GOVERNMENT HILL

P.O.A.D.P. / ~~P.U.D.~~

SUBDIVISION PLAT OF GOVERNMENT HILL UNIT 1A

Re: Government Hill POADP # 592

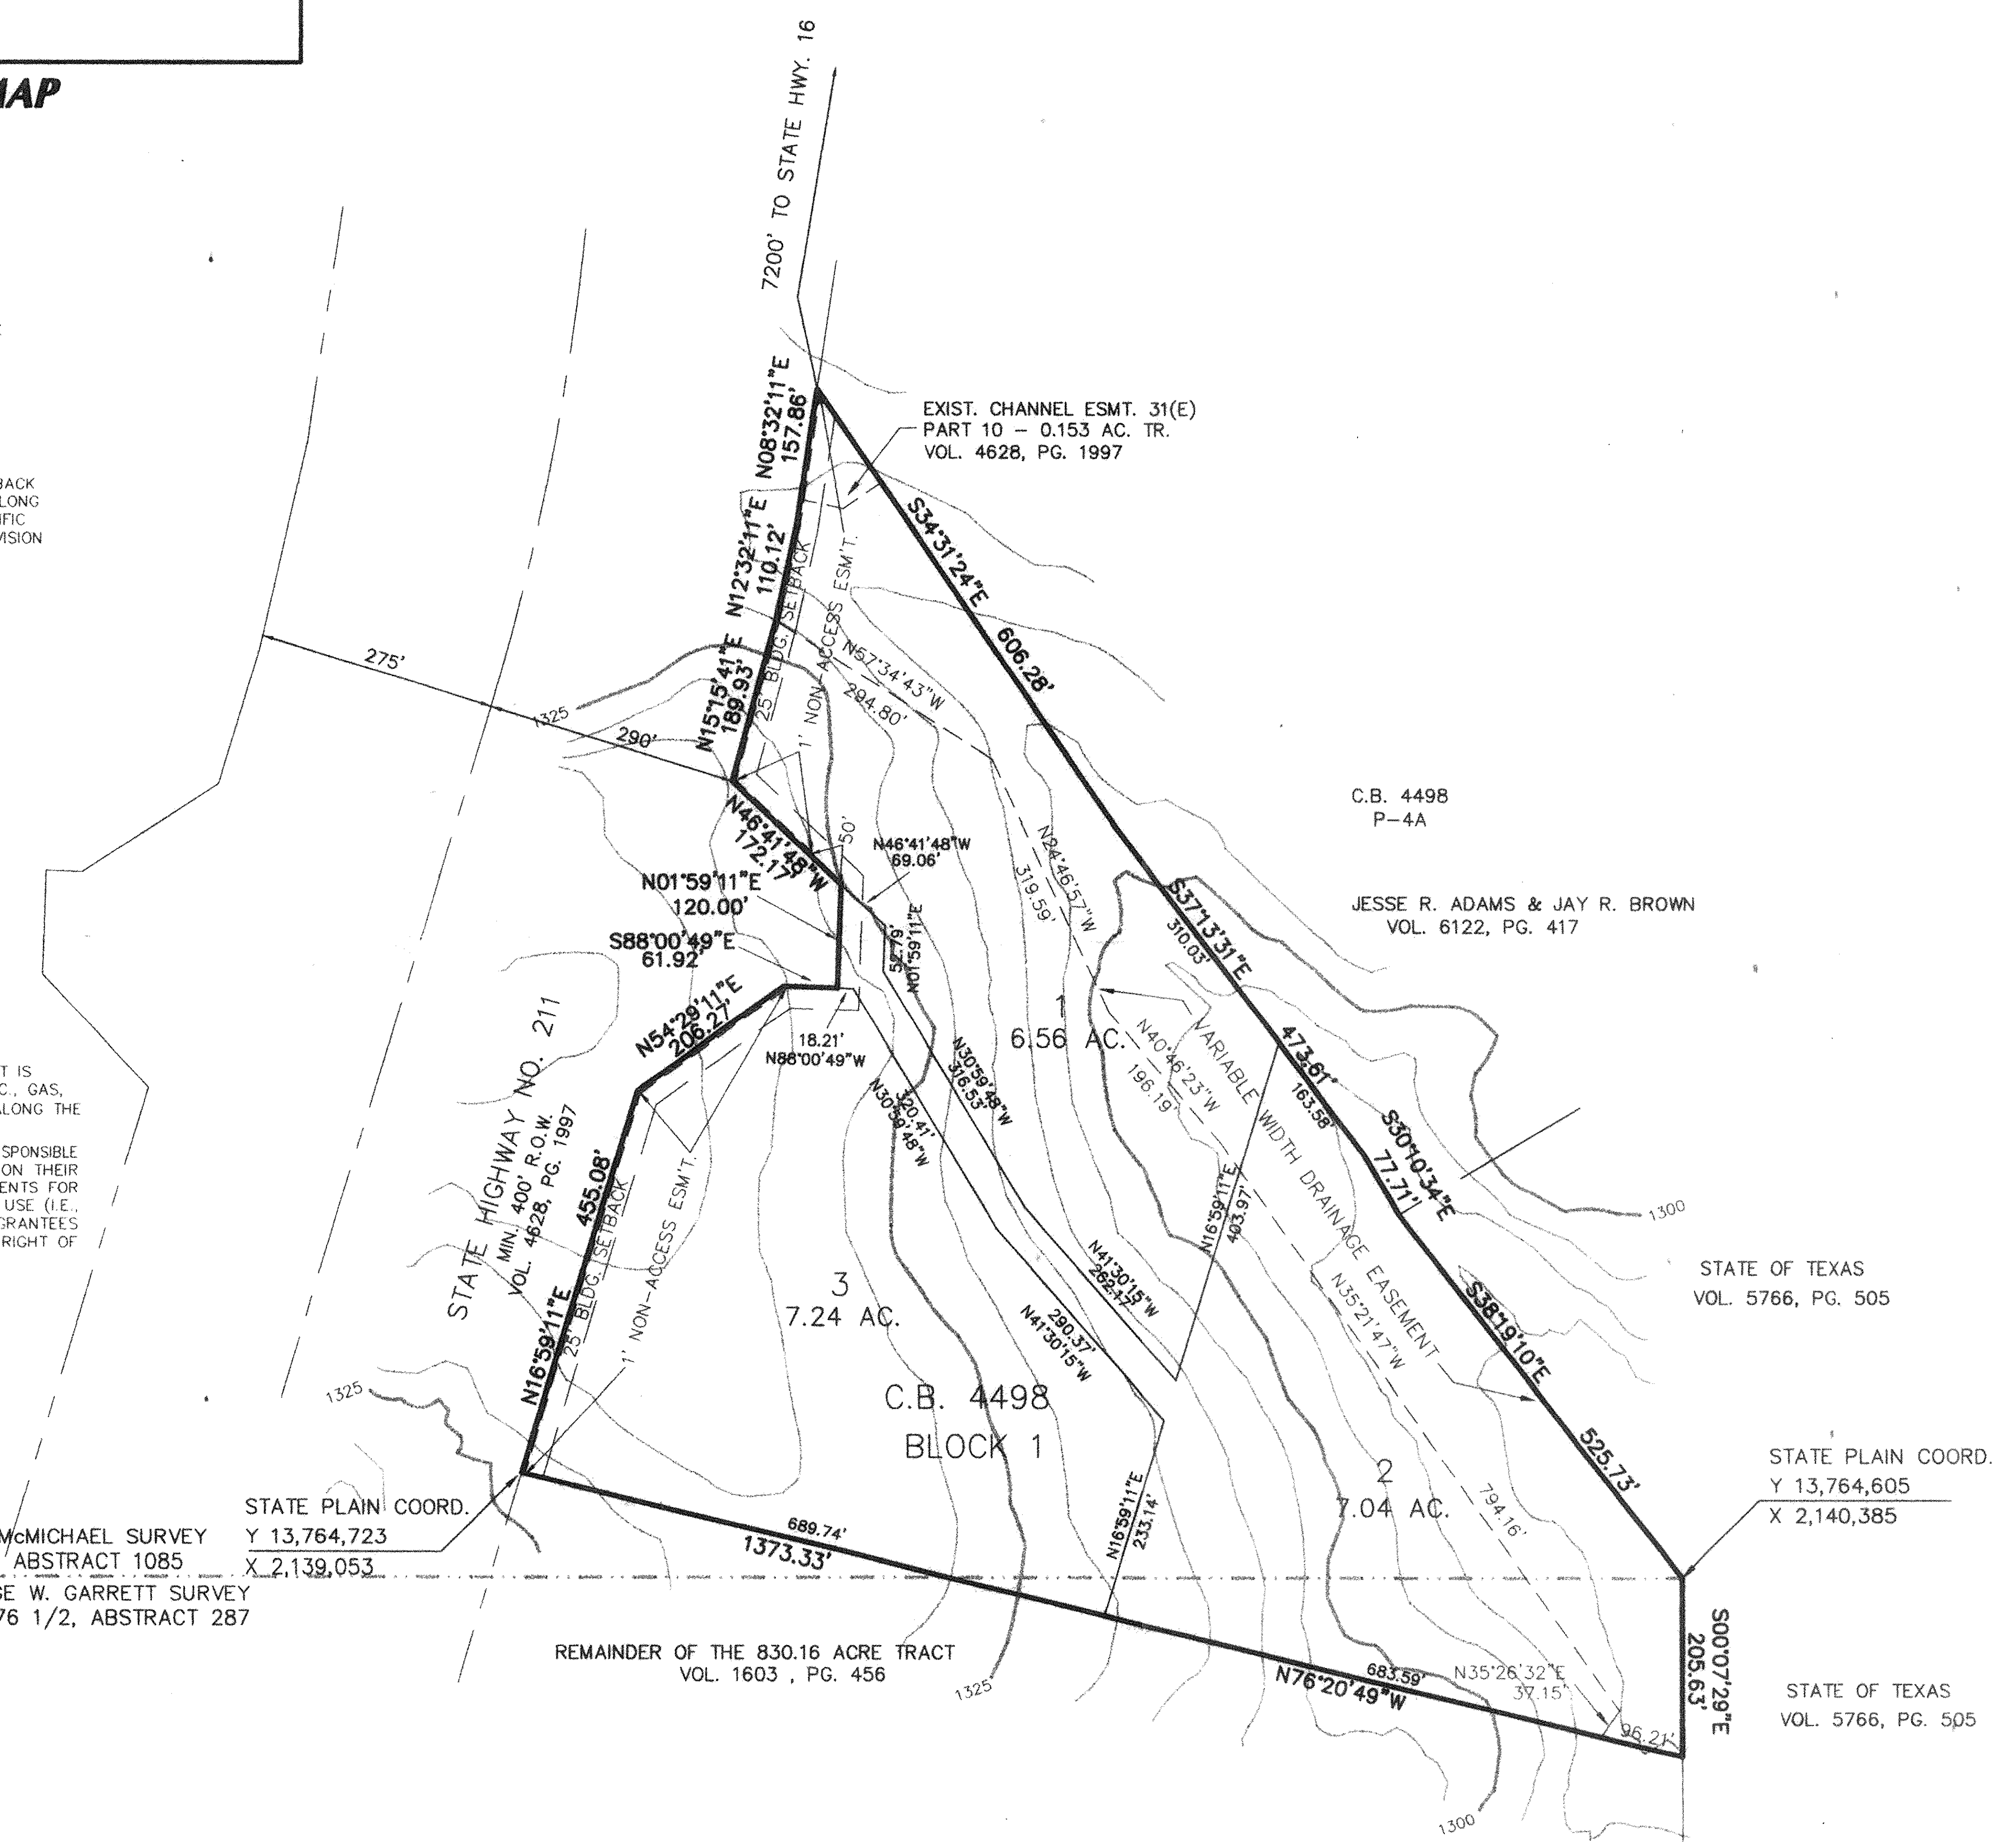
NO OBJECTION	OBJECTION
EXISTING R.O.W. DATA	JC	
PLANNED R.O.W. NEEDS		*JH
STREET, ALLEY & DRIVEWAY ACCESS	JLW	
OTHER (ENVIRONMENTAL)		**JF

REQUIRE THE FOLLOWING NOTES BE ANNOTATED ON YOUR PLAT:

(1) For residential development directly adjacent to State right of way, the Developer shall be responsible for adequate set-back and/or sound abatement measures for future noise mitigation.
(2) Owner/Developer is responsible for preventing any adverse impact to the existing drainage system within the highway right of way.
(3) Maximum access points to State highway from this property will be regulated as directed by "Regulations For Access Driveways To State Highways".
(4) Any sidewalks to be constructed within State right of way along freeway frontage roads will be located directly adjacent to the right of way line.

OTHER COMMENTS: *Request 1' non-access easement along entire highway frontage, except along line identified as N 01 59' 11" E. **Request copy of approved WPAP for this property.

8. FOR RESIDENTIAL DEVELOPMENT DIRECTLY ADJACENT TO STATE RIGHT OF WAY, THE DEVELOPER SHALL BE RESPONSIBLE FOR ADEQUATE SET-BACK AND/OR SOUND ABATEMENT MEASURES FOR FUTURE NOISE MITIGATION.

9. OWNER/DEVELOPER IS RESPONSIBLE FOR PREVENTING ANY ADVERSE IMPACT TO THE EXISTING DRAINAGE SYSTEM WITHIN THE HIGHWAY RIGHT OF WAY.
10. MAXIMUM ACCESS POINTS TO STATE HIGHWAY FROM THIS PROPERTY WILL BE REGULATED AS DIRECTED BY 'REGULATIONS FOR ACCESS DRIVEWAYS TO STATE HIGHWAYS'.

11. ANY SIDEWALKS TO BE CONSTRUCTED WITHIN STATE RIGHT OF WAY ALONG FREEWAY FRONTAGE ROADS WILL BE LOCATED DIRECTLY ADJACENT TO THE RIGHT OF WAY LINE.
